13 - BODY

Door locks – All 505 models

From serial number 551 . . . 1 669 842,

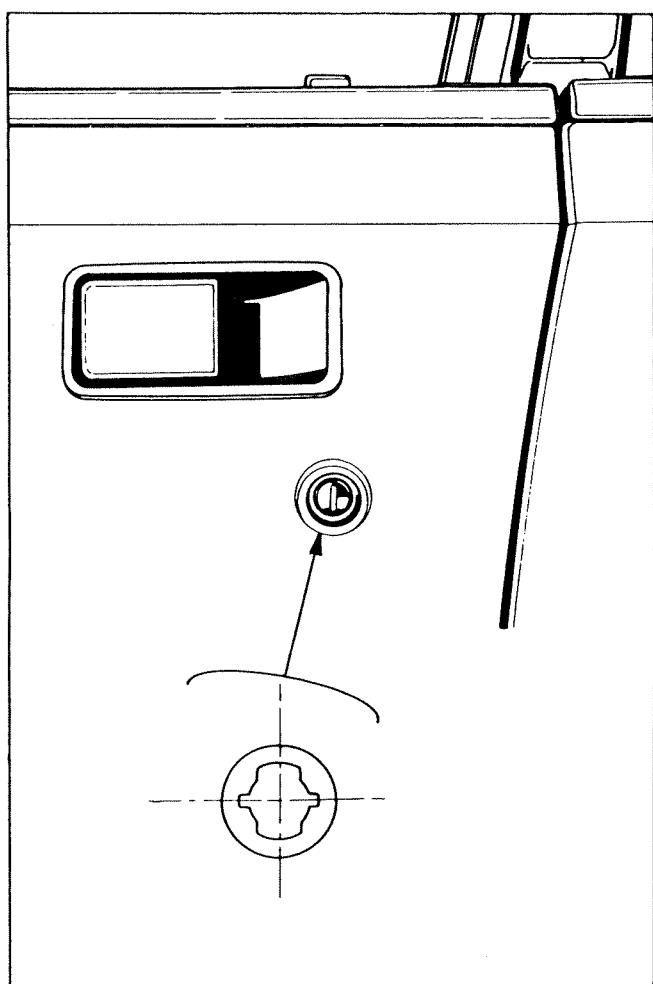
all 505 models are fitted with front private door locks of the 205 type, with a larger diameter.

Consequently, the front door panels have a larger piercing and escutcheon (35 mm in place of 30 mm).

Identification

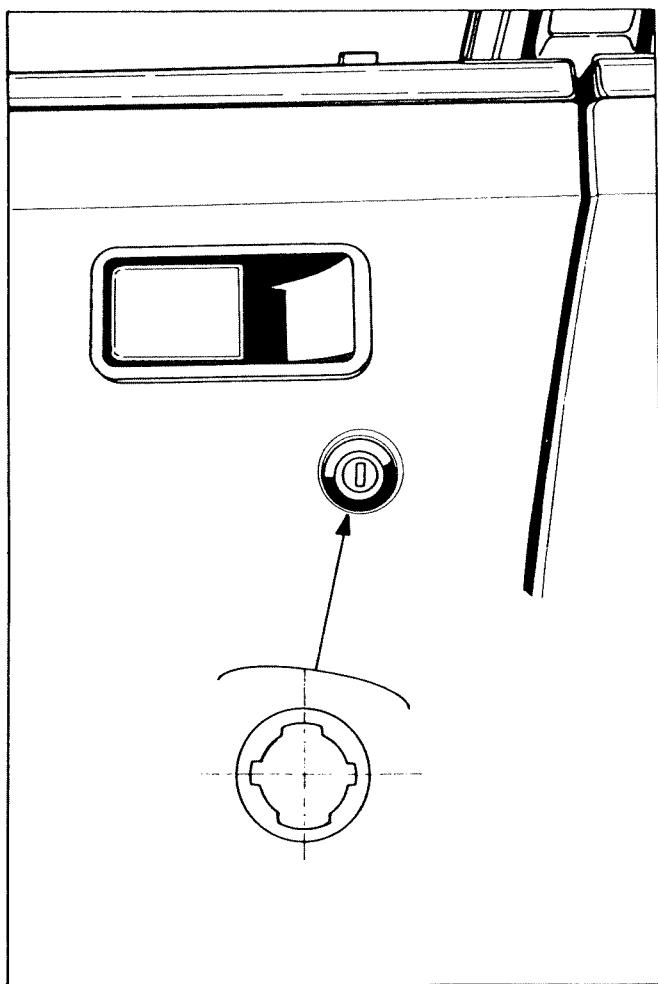
Earlier fitting

Later fitting

When changing a front door or door outer panel, in order to fit the earlier type lock to the later part, it is necessary to fit an adaptor (1) (Part No. 9170.58). Observe the correct fitting position.
